ALERT SERVICE BULLETIN

NO. 407-99-28

MODELS AFFECTED: 407

SUBJECT: ENGINE FADEC ELECTRONIC CONTROL UNIT (ECU), UPGRADE OF.

Figure 1 Electronic Control Unit (ECU) – Installation (Sheet 1)

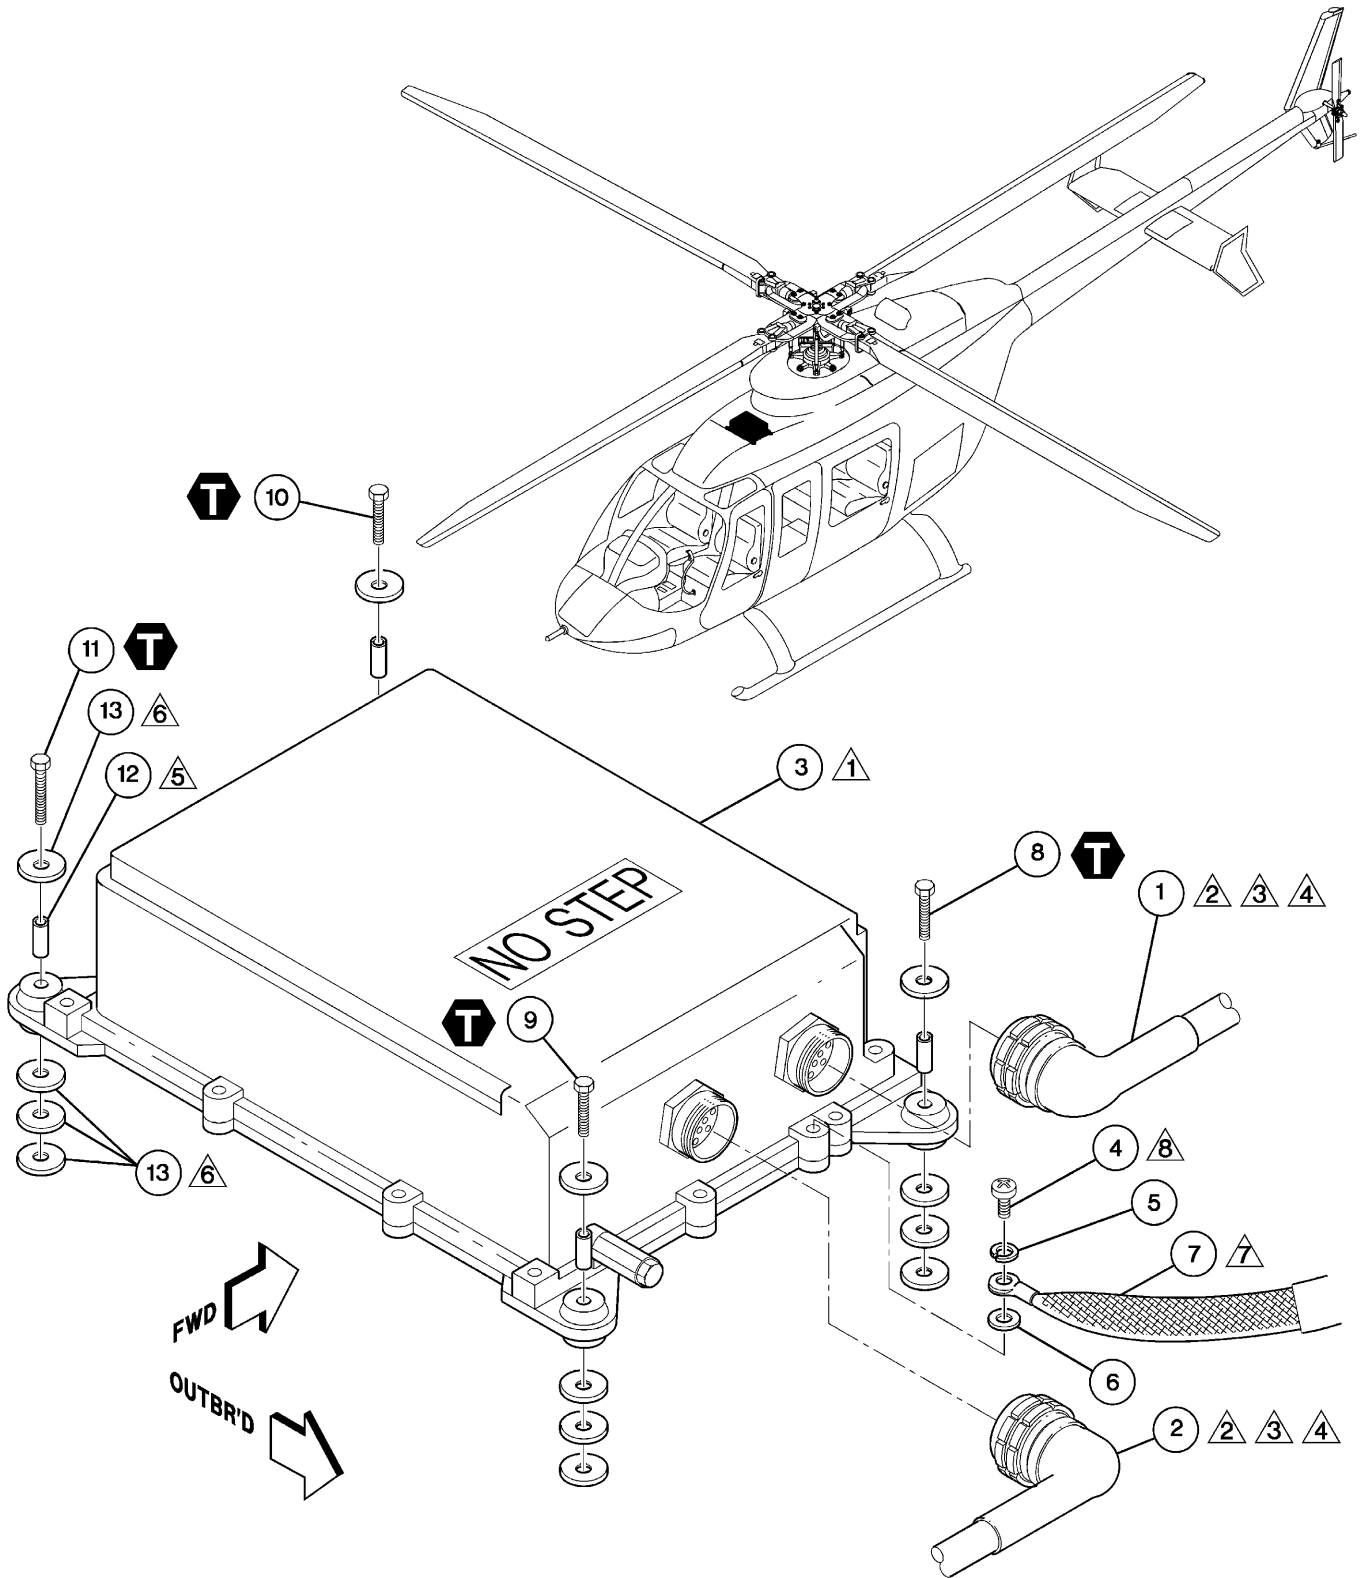
3. Remove the FADEC ECU 23070254. Install the version 5.202 FADEC ECU, 23070264. Refer to Figure 1 for the removal and installation. Make sure that the spacers (12) are installed in each of the ECU mounting pad isolation dampers. The ECU installation must agree with Figure 1 before the helicopter is put in service.
